Re: World Trade Center- Standpipe System during Construction of Office Towers

The following is a summary of the understanding of the requirements of the 2008 Building Code sections discussed at the meeting.

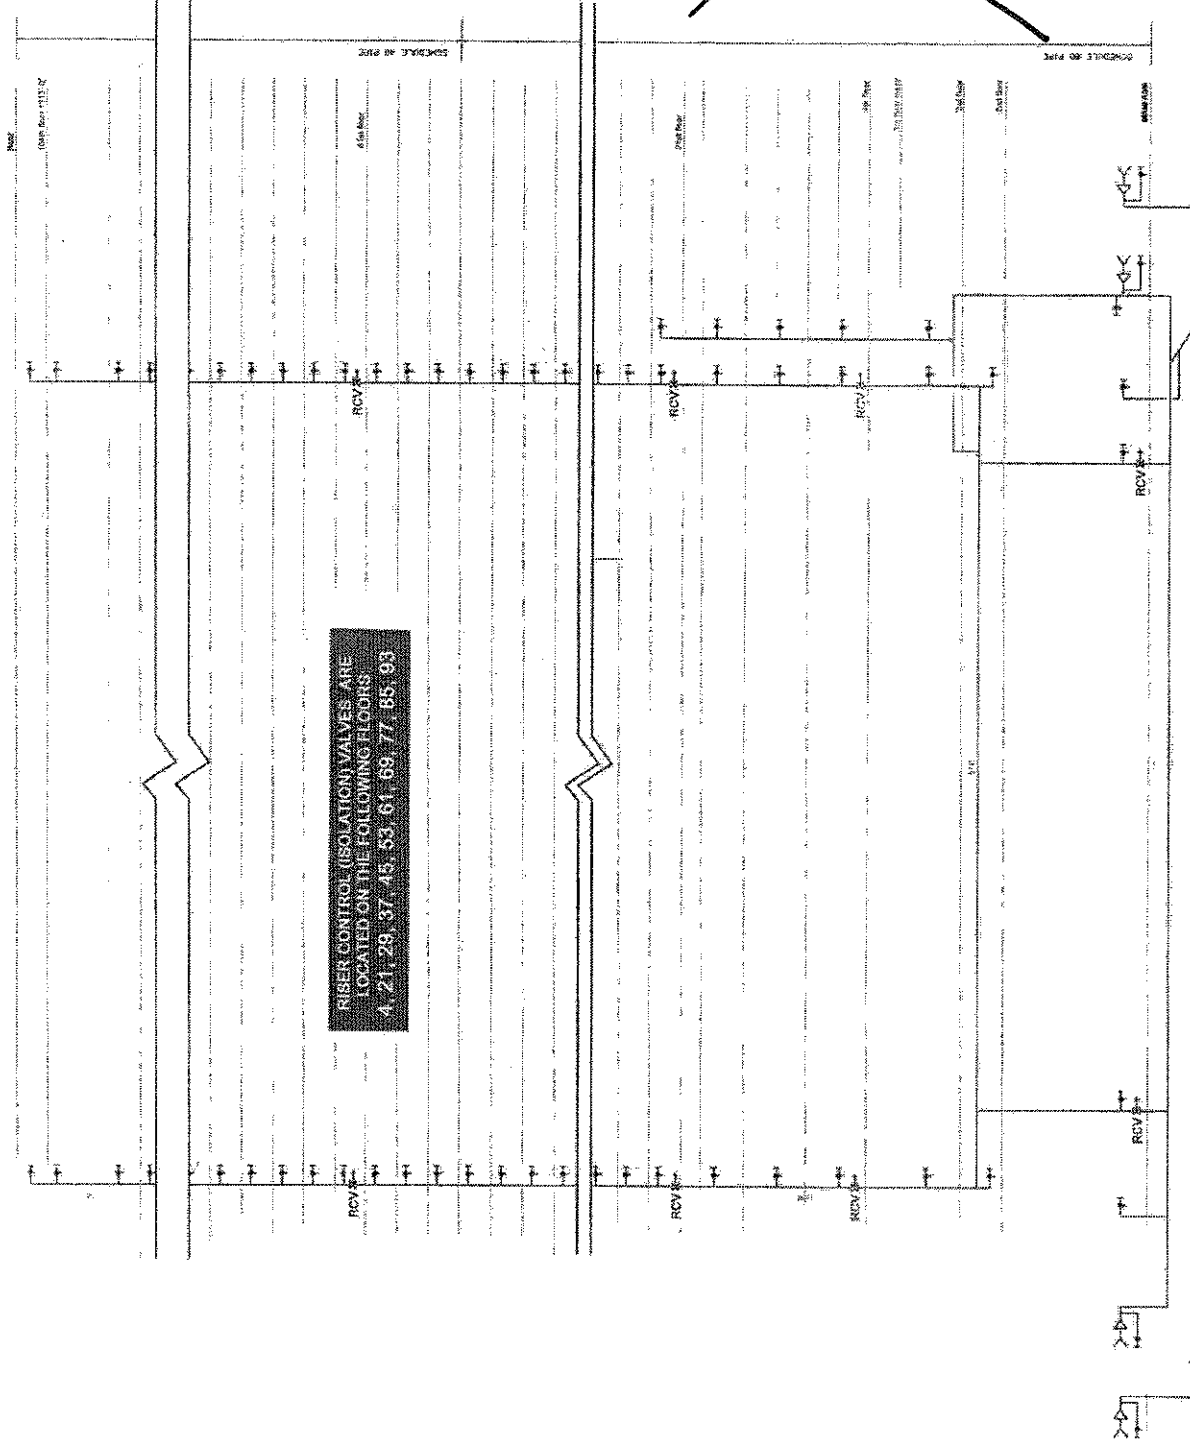
WHY DO WE NEED THIS..?

14500 w/ Riser
- NO PE -
NEED TO REVIEW APPROVED DESIGN
RISER
STAIN
ANY OFFSETS
